UNITED STATES PATENT AND TRADEMARK OFFICE

10/613,605

Office Action Summary	Application No. 10/613,605	Applicant(s) DEROGATIS ET AL.	
	Examiner Ernesto Garcia	Art Unit 3679

DETAILED ACTION

Rapata, 3,539,234

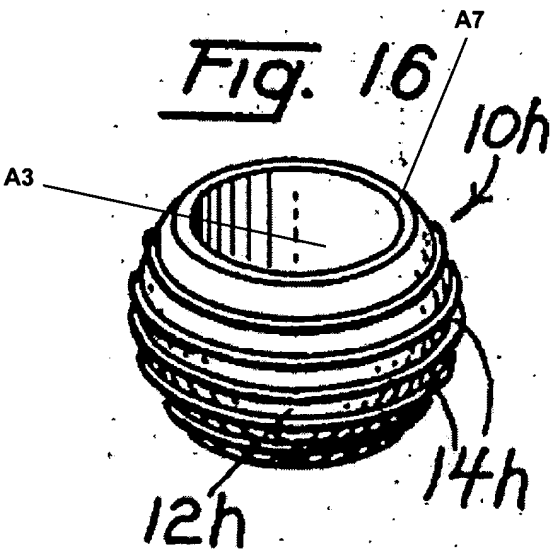
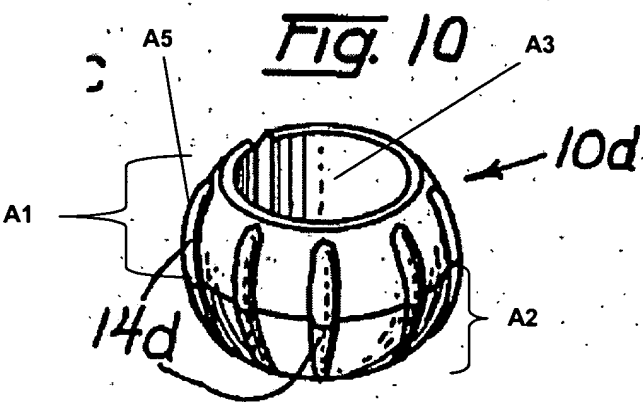
Claims 1,7, 8, 11, 13, 49-52, 54, 56-61, and 63 are rejected under 35 U.S.C. 102(b) as being anticipated by Rapata, 3,539,234 (see marked-up attachment).

Regarding claim 1, Rapata discloses, in Figure 16, a plug fastener **10d** comprising a first engaging portion **A1** and a second engaging portion **A2**. The first engaging portion **A1** has first ridges **14d**. The second engaging portion **A2** has second ridges **14d**. The first ridges **14d** are slanted with respect to the second ridges **14d**. An aperture **A3** extends through the plug fastener. The first ridges **14d** and the second ridges **14d** are concentric with respect to the aperture **A3**.

Regarding claim 7, at least one of the first ridges **A1** or the second ridges **A3** comprises an angled top surface **A5**. The angled top surface provides the slant of the first ridges **14d** or the second ridges **14d**.

Regarding claim 57, Rapata discloses in Figure 16, a substantially plug fastener **10h** comprising an aperture **A3**, a first hemisphere **A1**, and a second hemisphere **A2**. The aperture **A3** extends through the plug fastener and has a first opening **A7** and a second opening (below opposite to **A7**). The first hemisphere **A1** has first ridges **14d** concentric and orthogonal with respect to the aperture **A3**. The first hemisphere **A1** includes the first opening **A7**. The second hemisphere **A2** has second ridges **14h** concentric and orthogonal with respect to the aperture **A3**. The second hemisphere **A2** includes the second opening. Ends of the first ridges **14h** and the second ridges **14h** are tapered respectively from the first opening and the second opening towards a maximum diameter of the fastener **10h** (note that the ridges are curved such that half of the curved is tapered towards the maximum diameter).

Waldron, 3,438,659

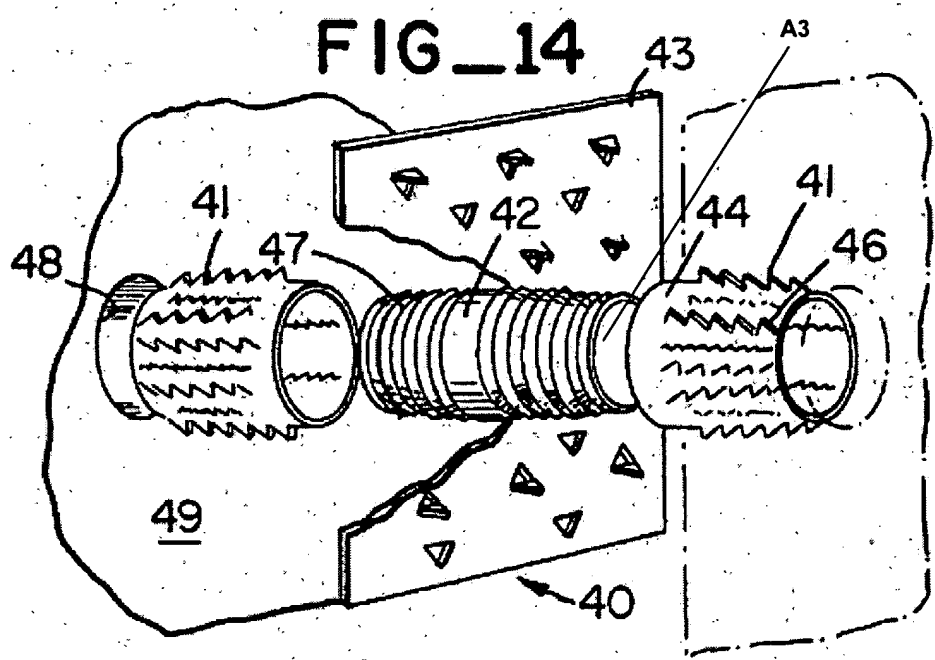
Claims 1, 7, 8, 11, 13, 49, and 50 are rejected under 35 U.S.C. 102(b) as being anticipated by Waldron, 3,438,659.

Regarding claim 1, Waldron discloses, in Figure 14, a plug fastener **42** comprising a first engaging portion and a second engaging portion. The first engaging portion has first ridges **47**. The second engaging portion has second ridges **47**. The first ridges **47** are slanted with respect to the second ridges **47**. An aperture **A3** (see marked-up attachment) extends through the plug fastener **42**. The first ridges **47** and the second ridges **47** are concentric with respect to the aperture **A3**.

Regarding claim 7, at least one of the first ridges **47** or the second ridges **47** comprises an angled top surface **A5**. The angled top surface provides the slant of the first ridges or the second ridges.

FIG. 8

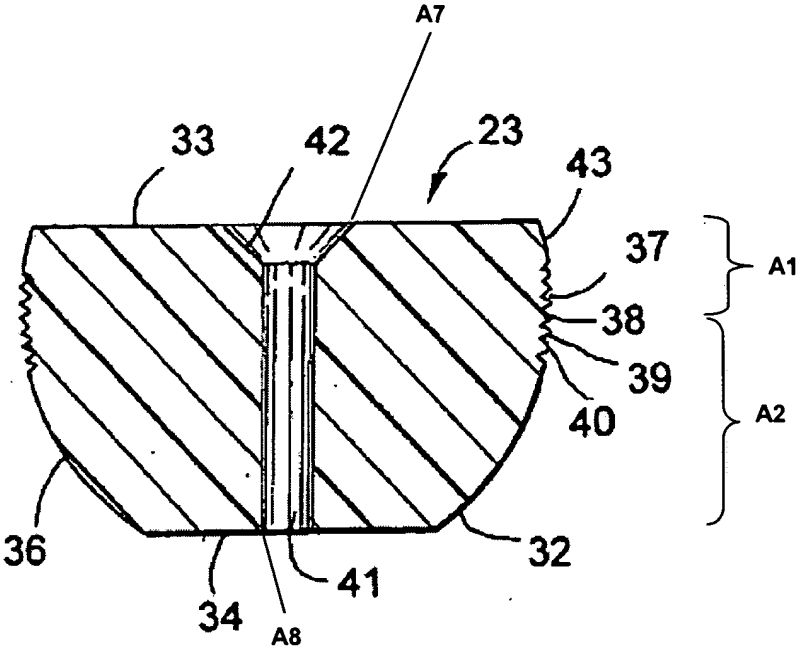
Claims 1, 53, 54, 55, 57, 62-64 are rejected under 35 U.S.C. 103(a) as being unpatentable over Harder, 6,932,329, in view of Astl, 5,131,783.

Regarding claim 1, Harder discloses, in Figures 7 and 8, a plug fastener **23** comprising a first engaging portion **A1** and a second engaging portion **A2**. The first engaging portion **A1** has first ridges **37,38**. The second engaging portion **A2** has second ridges **39,40**. An aperture **41** extends through the plug fastener **23**. The first ridges **37,38** and the second ridges **39,40** are concentric with respect to the aperture **41**. However, Rapata fails to disclose the first ridges **37,38** slanted with respect to the second ridges **39,40**. Astl teaches, in Figure 5, different types of ridges for being more rigid due to greater supporting area (col. 3, lines 61-68). In particular, the fourth embodiment provides the first ridges being slanted with respect to the second ridges when the ridges of Harder are substituted for those of Astl. Therefore, as taught by Astl, it would have been obvious to one of ordinary skill in the art at the time the invention was made to replace the ridges of Harder with any known ridge design so that the

Regarding claim 53, the aperture **41** further comprises at least one countersink **42** formed at one end of the aperture **41**.

Regarding claim 57, Harder discloses in Figures 6 and 7, a substantially plug fastener **23** comprising an aperture **41**, a first hemisphere **A1**, and a second hemisphere **A2**. The aperture **41** extends through the plug fastener and has a first opening **A7** and a second opening **A8**. The first hemisphere **A1** has first ridges **37,38** concentric and orthogonal with respect to the aperture **41**. The first hemisphere **A1** includes the first opening **A7**. The second hemisphere **A2** has second ridges **39,40** concentric and orthogonal with respect to the aperture **41**. The second hemisphere **A2** includes the second opening **A8**. However, Harder fails to disclose ends of the first ridges **37,38** and the second ridges **39,40** being tapered respectively from the first opening and the second opening towards a maximum diameter of the fastener **23**. Astl teaches, in Figure 5, different types of ridges for being more rigid due to greater
